Environmental Impact Statement

ERATTA NO. 01

N4 Collooney to Castlebaldwin Proposed Road Development

Project N4 Collooney to Castlebaldwin Proposed Road Development		
Title Flooding: Flood Risk Mitigation (Toberscanavan Loughs/Markree Demesne Stream)		
Scales (@A3) 1:3,000	Date December 2013	Job No. SO/01/150
Design HydroE/FM	Design Team Review FM	Approved AS
		Figure No.: Fig.: 4.9.1

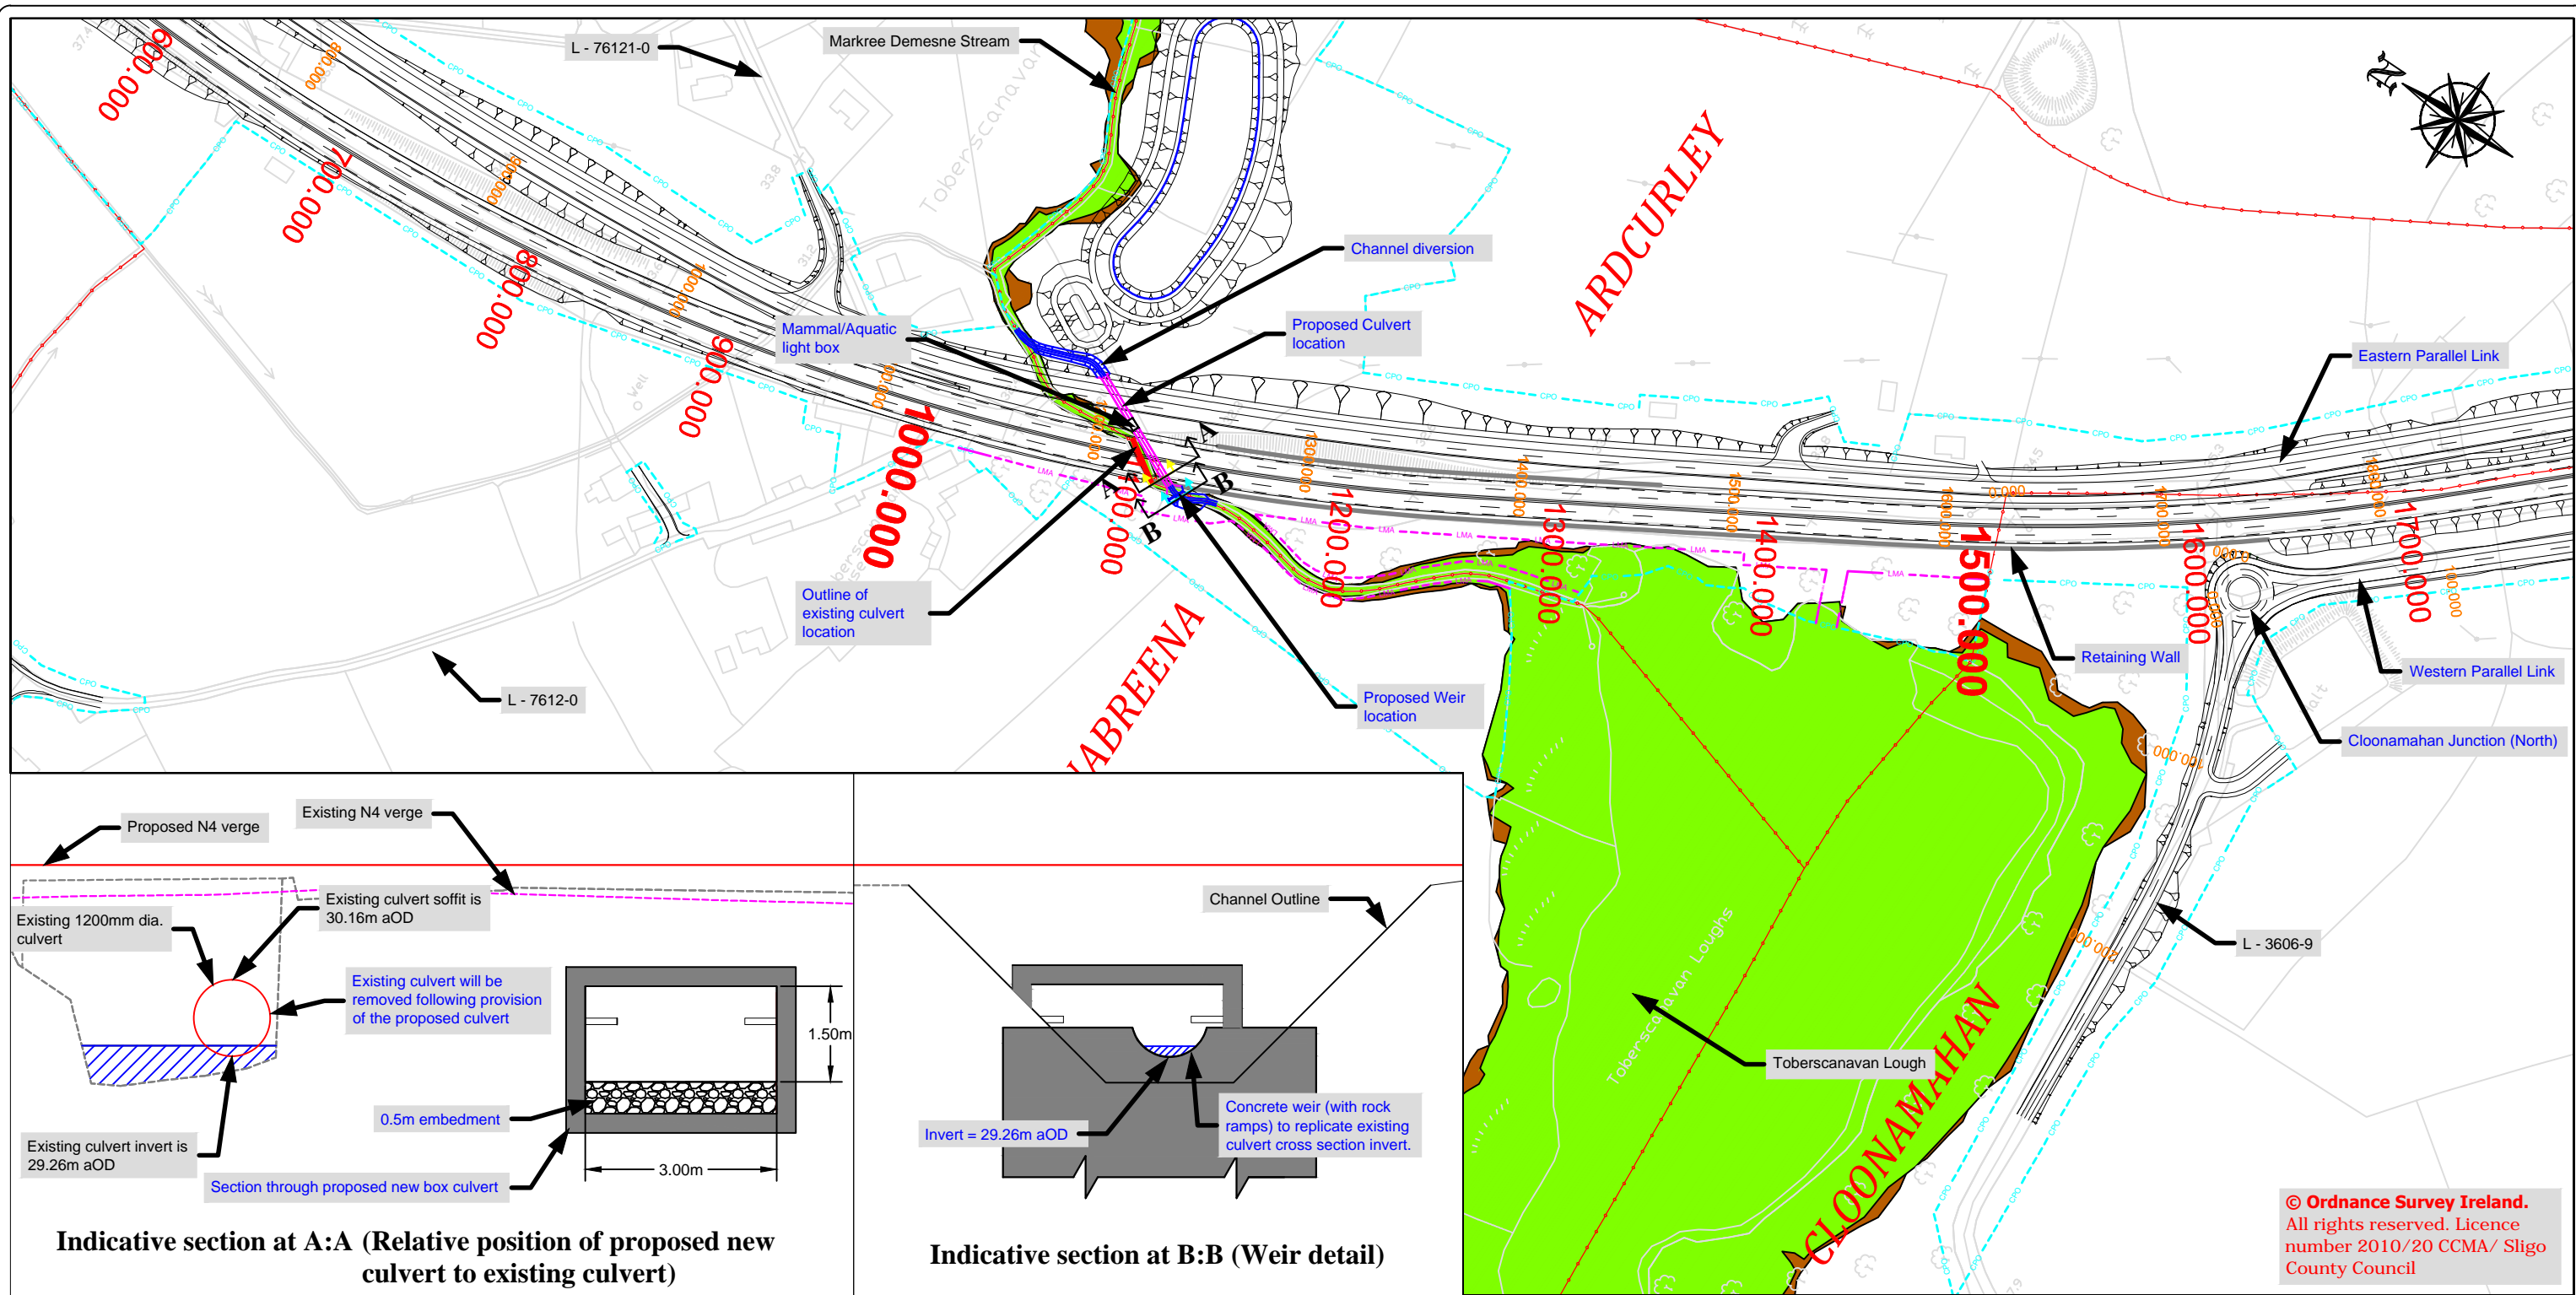
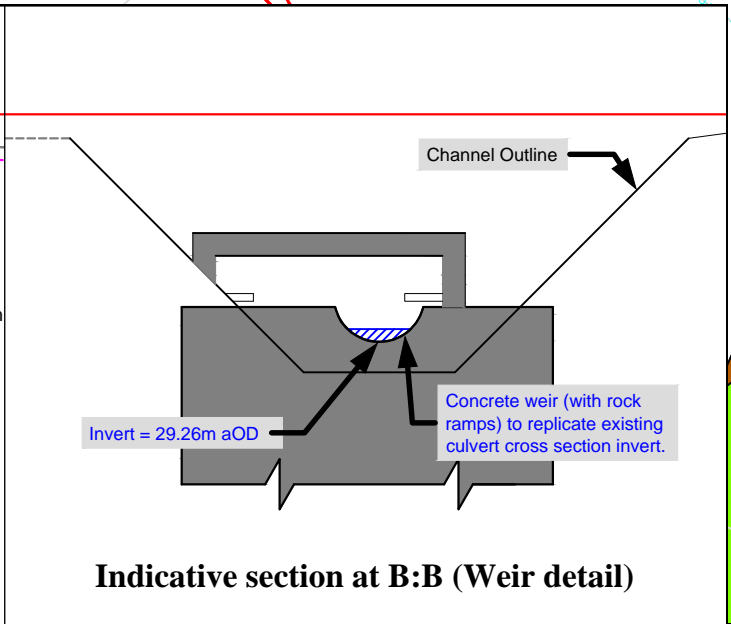
Figure 4.9.1

The amendment to the weir proposal described in section 2.1 (section 4.8.5.1.4) of this document is amended.

Date	By	Revision
April 2014	FM	This is an errata to the EIS as described in Errata Sheet No. 01.
		The previously referred to adjustable weir is replaced by an unadjustable one with rock ramp weir approaches.
		The culvert is moved slightly further to the south. The weir location is not modified.

Project N4 Collooney to Castlebaldwin Proposed Road Development		
Title Flooding: Flood Risk Mitigation (Turnalaydan Stream)		
Scales (@A3) 1:3,000	Date December 2013	Job No. SO/01/150
Design HydroE	Design Team Review FM	Approved AS
Figure No.: Fig.: 4.9.2

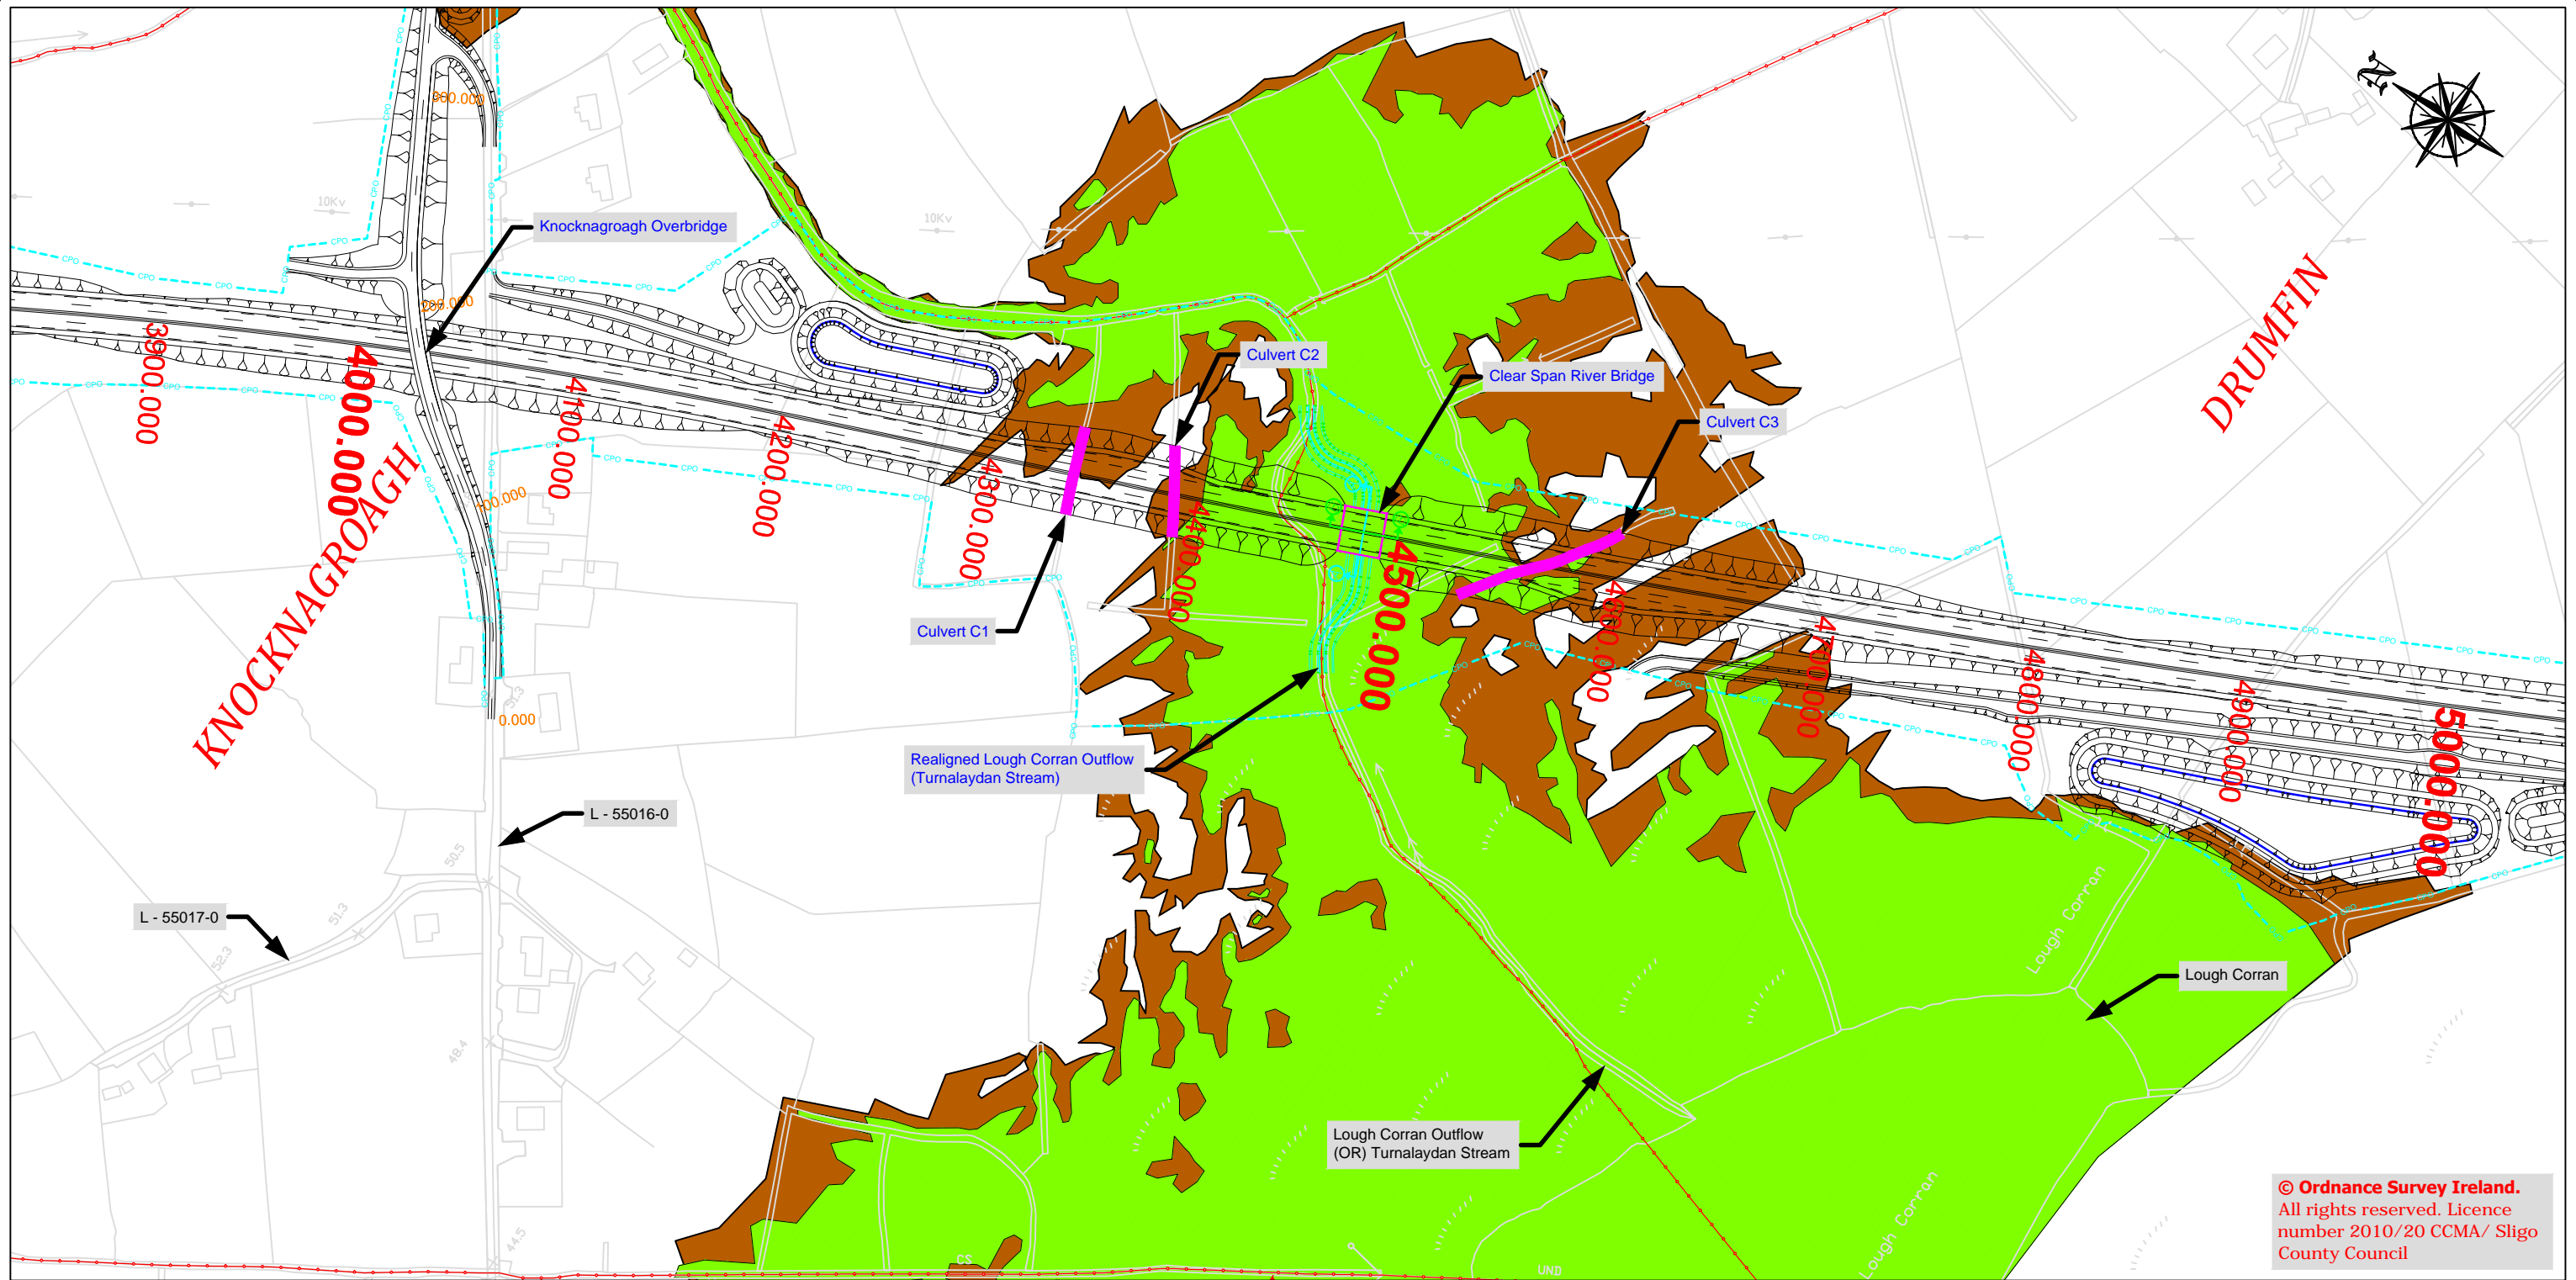
Figure 4.9.2

This map corrects printing errors in the flood plain mapping. The new map now corresponds to maps which are included in the Flood Risk Assessment Report (Appendix 4.2).

Date	By	Revision
April 2014	FM	This is an eratta to the EIS as described in Eratta Sheet No. 01. Printing errors to the flood plain mapping have been corrected.

Figure No.:
Fig.: 4.9.4

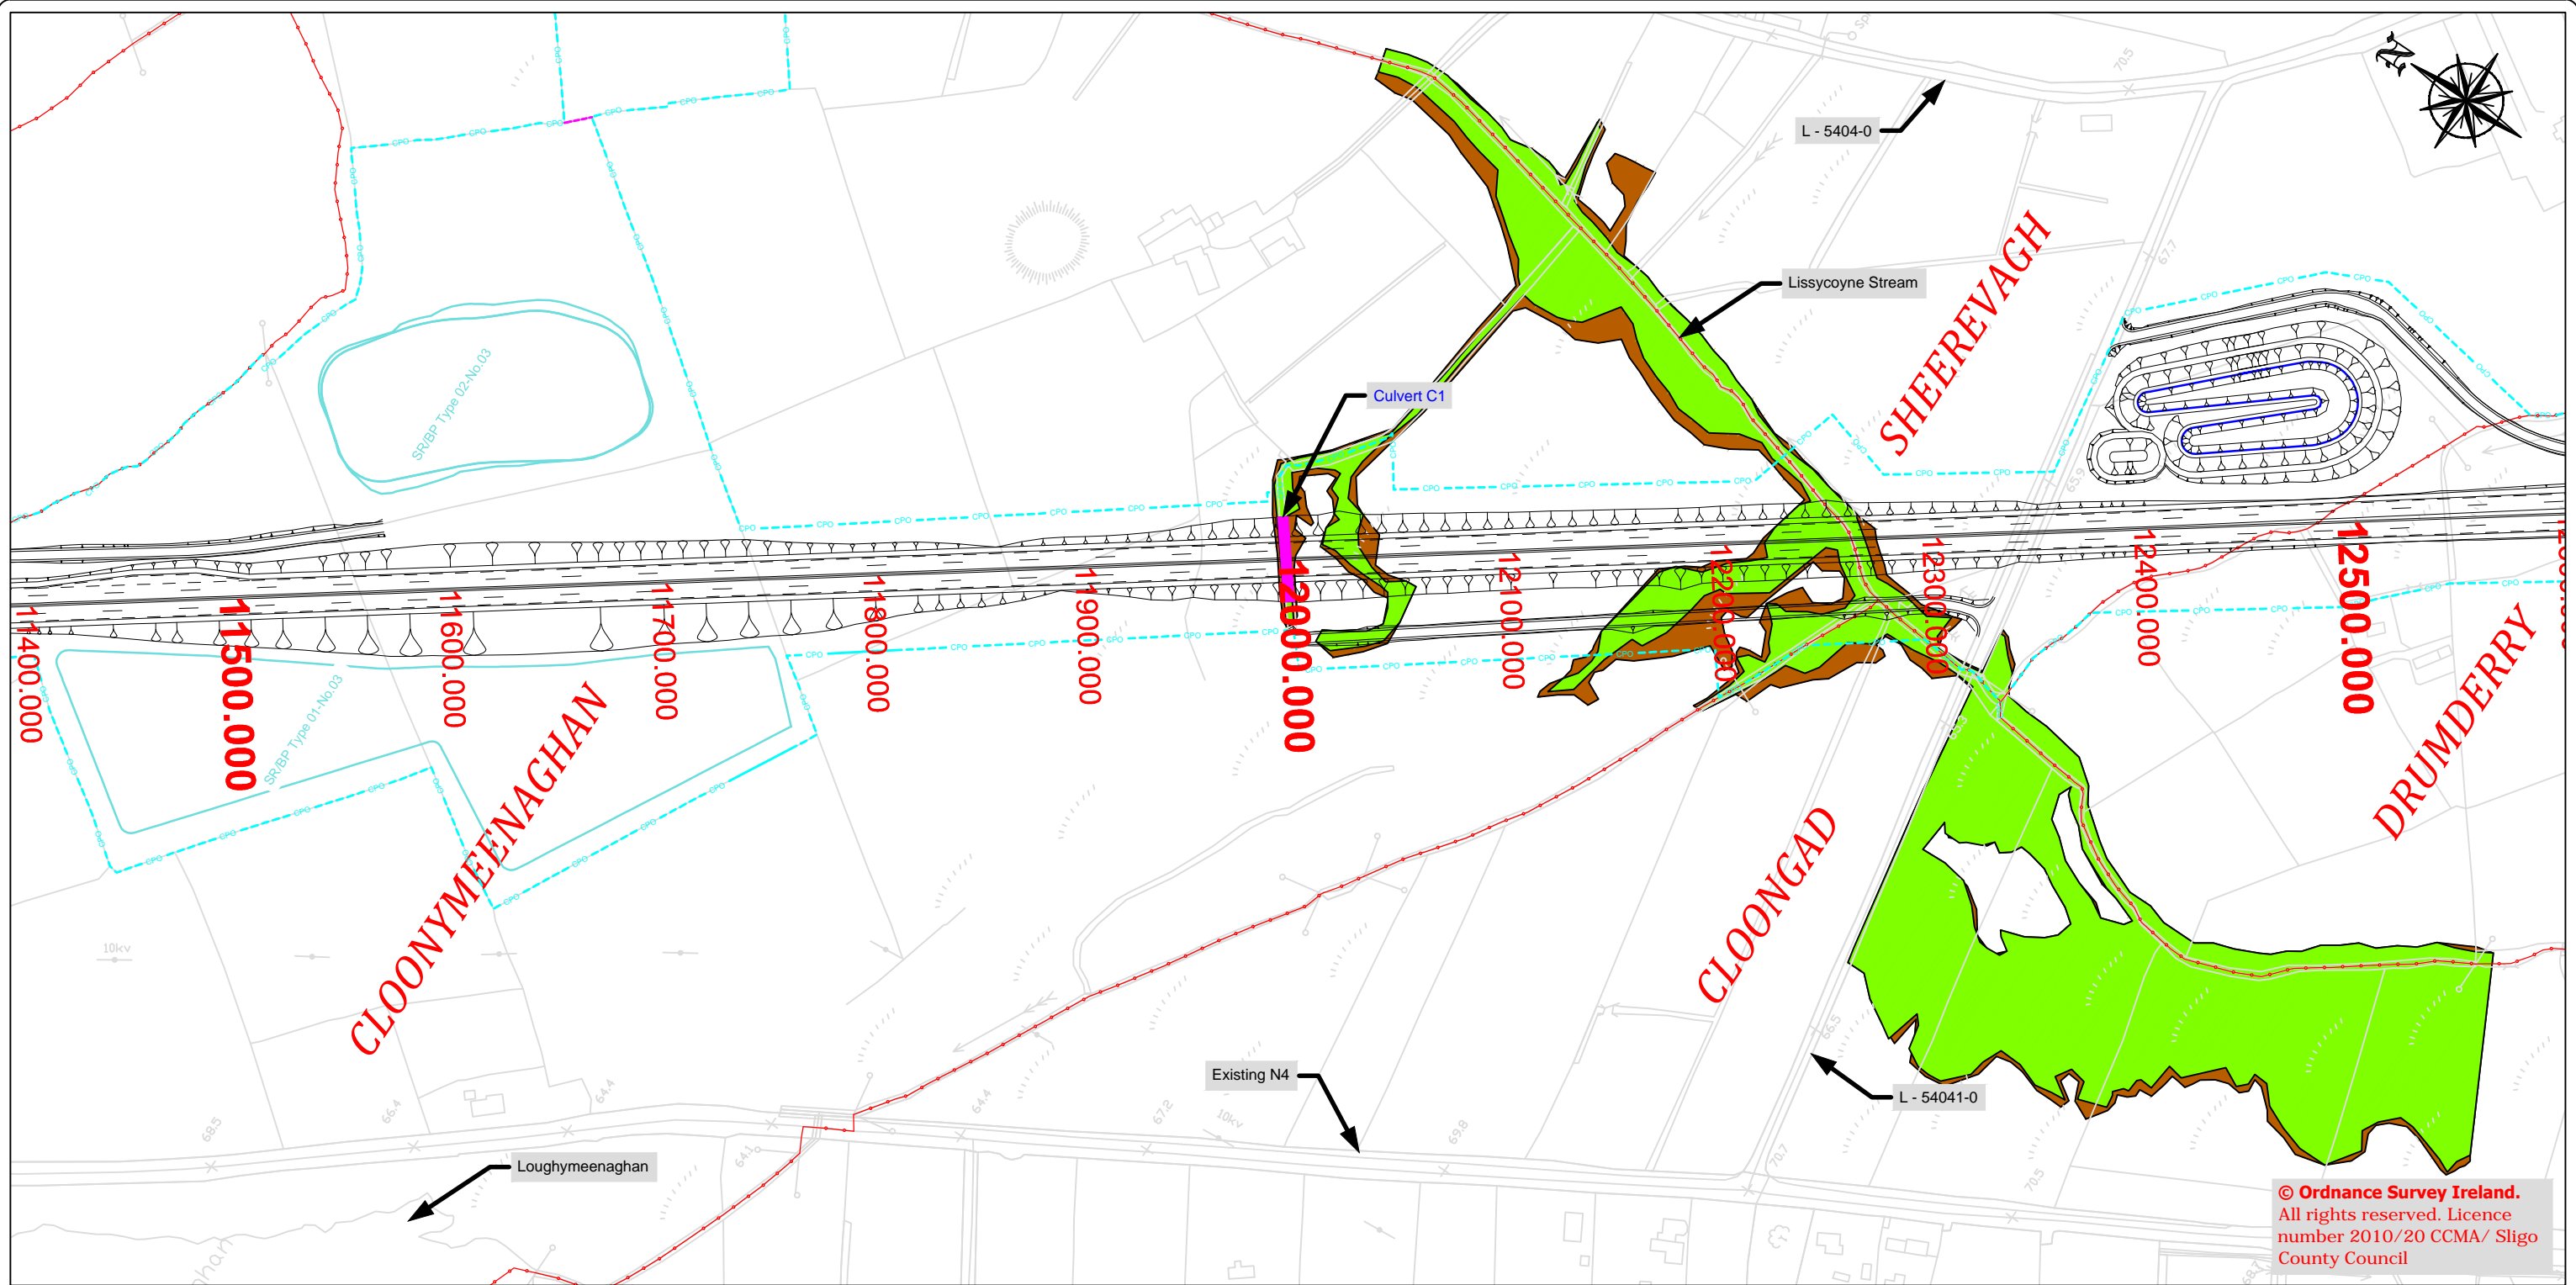
Figure 4.9.4

This map corrects printing errors in the flood plain mapping. The new map now corresponds to maps which are included in the Flood Risk Assessment Report (Appendix 4.2).

Date	By	Revision
April 2014	FM	This is an errata to the EIS as described in Errata Sheet No. 01. Printing errors to the flood plain mapping have been corrected.
